Greggs bakery | Twickenham  
PPA Meeting 1

## Proposed amendments

## Rear garden sizes

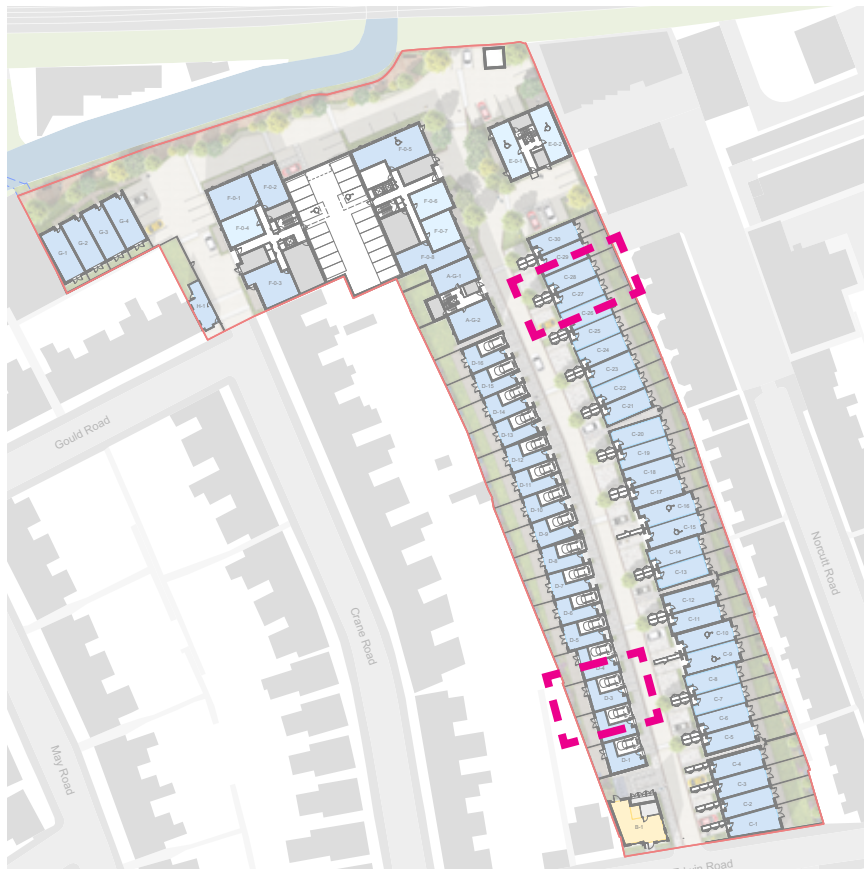
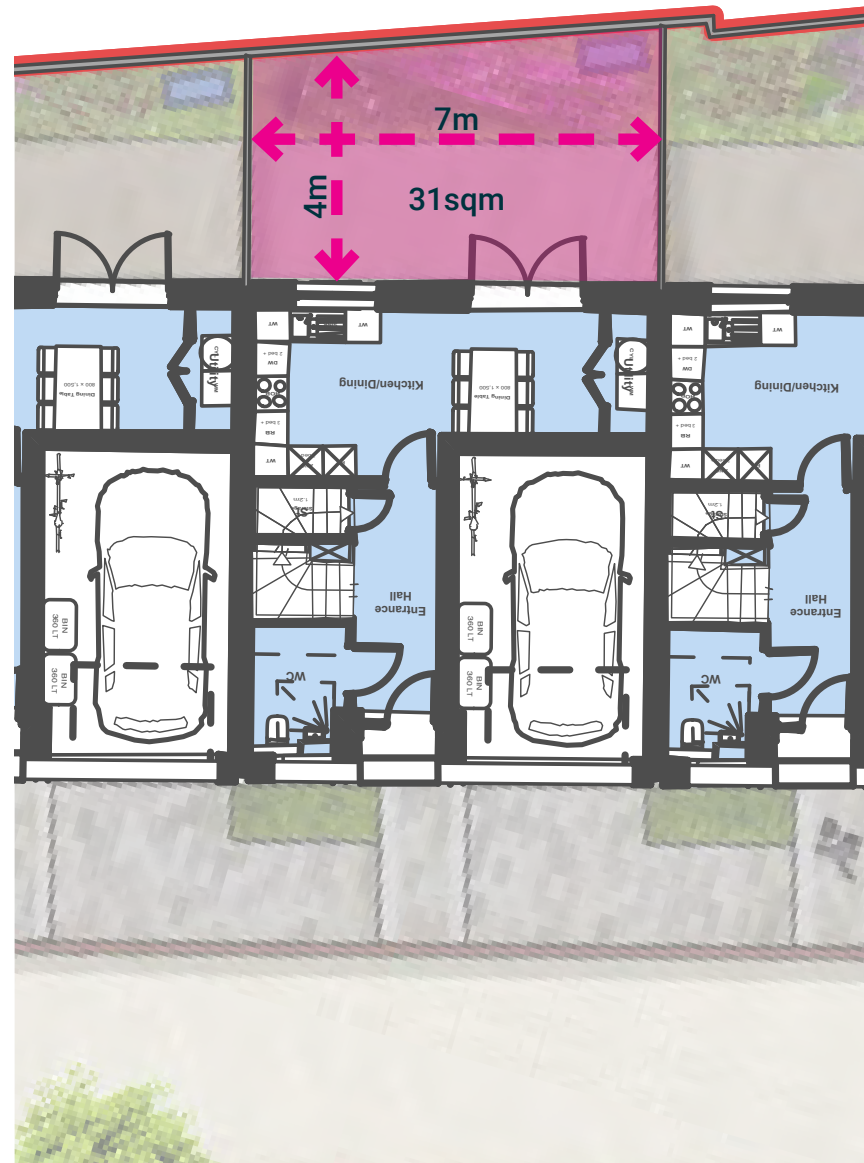
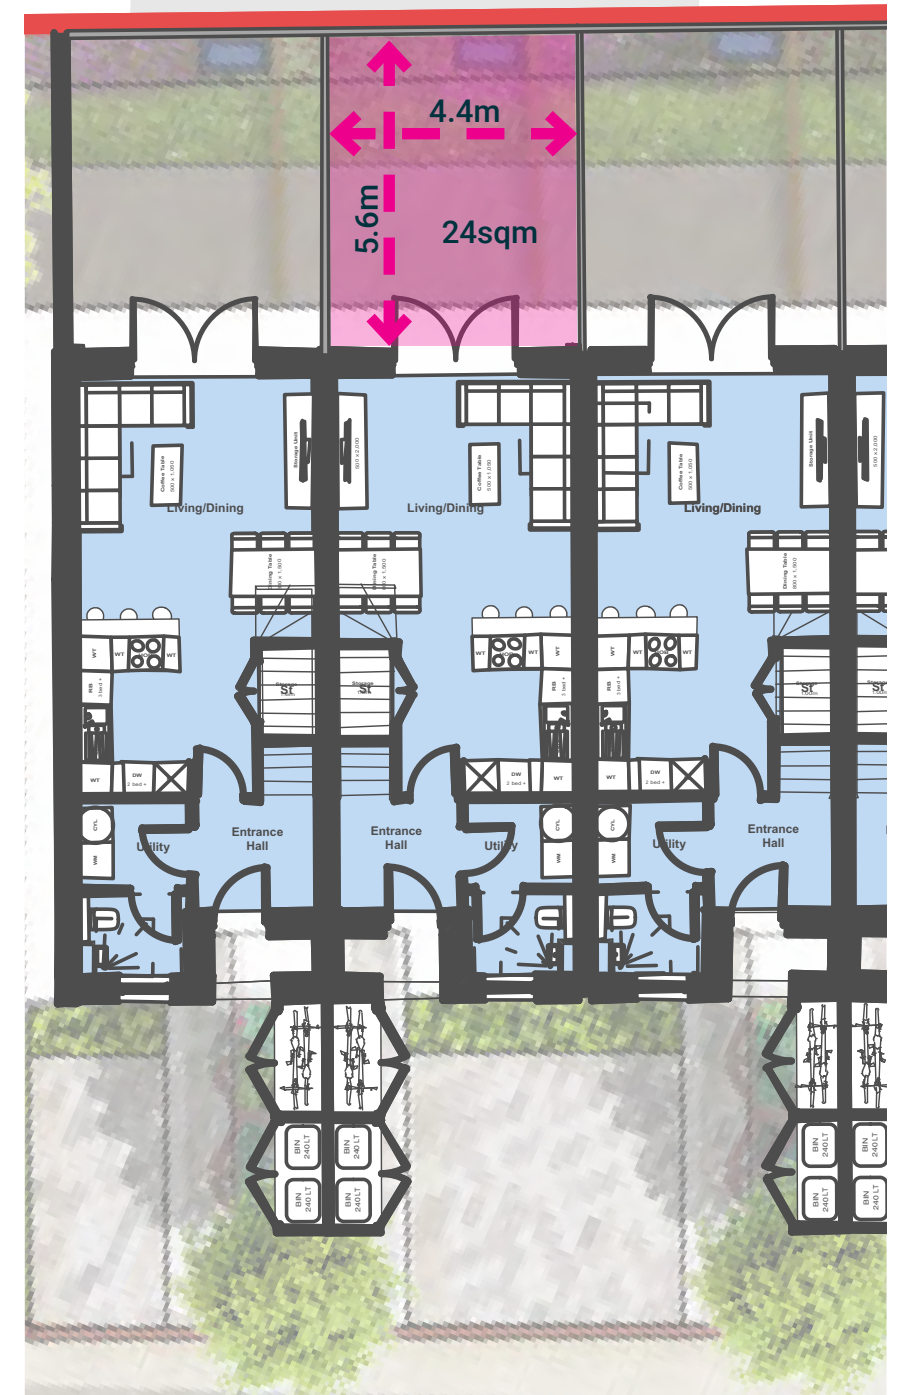
Lack of amenity space for houses (specifically C15-C30 and D1-D7). Adjust the typology and provide more generous space. Explore the inside outside relationship to make them more usable.

Increase in back garden depths is supported and are policy compliant however some still remain small.

- House types C-15 to C30 shortened to increase garden sizes. (Houses remain London Plan Compliant)
- Accessible houses relocated elsewhere where gardens were tighter
- Patio doors to be provided with level threshold giving seamless access to the gardens, creating use-able inside outside space
- House layouts D1-D4 amended to improve relationship with the garden
